Tippecanoe County Board of Commissioners

Meeting
Monday, May 4, 2020
10:00 am
Tippecanoe Room, Tippecanoe County Office Building
20 N 3rd Street, Lafayette, Indiana

AIA® Document G701/CMa™ – 1992

PROJECT *(Name and address)*:
885-Fairground Renovations
1406 Teal Rd.
Lafayette, IN 47905

Date 3/12/20 Project 885 - COLISEUM Sheet #

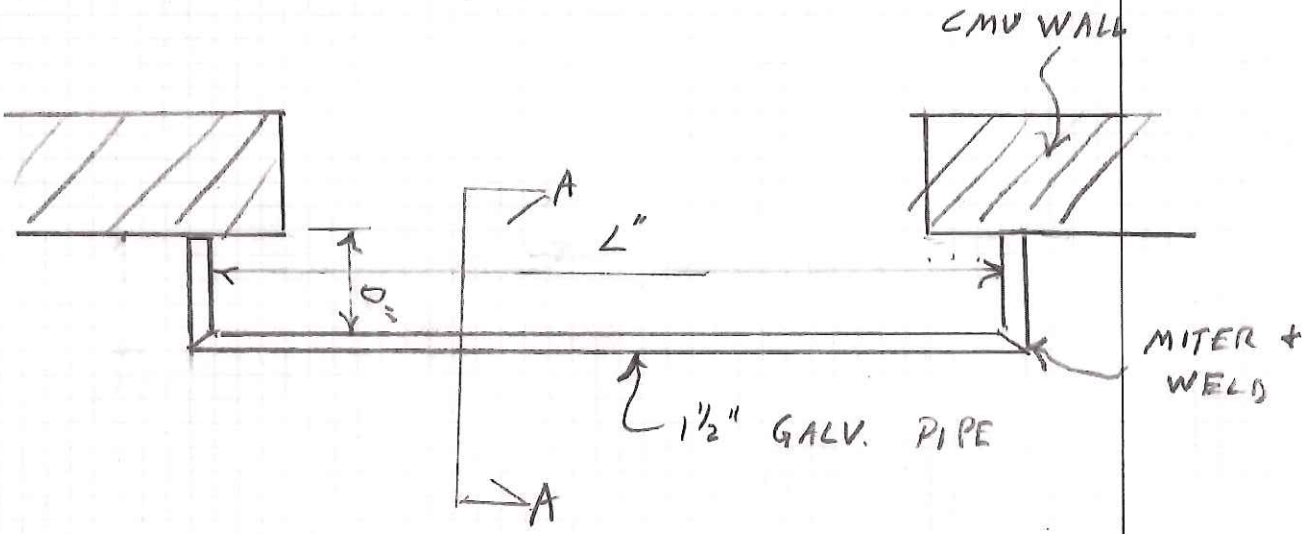
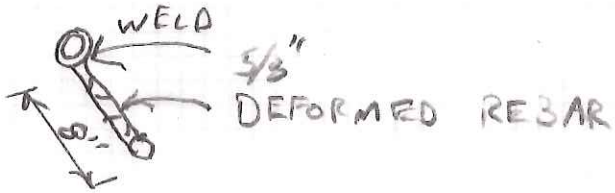
EWO 885-084

[] Add slab-on-grade 3/4" depression embeds at 6 ea. exterior overhead doors per attached detail.

@ OVERHEAD DOORS 106D, 119E - 126D

L = 24'-8"

D = 7"

@ OVERHEAD DOORS 124C, 125C + 126C, 137D, and 137C

L = 12'-8"

D = 6"
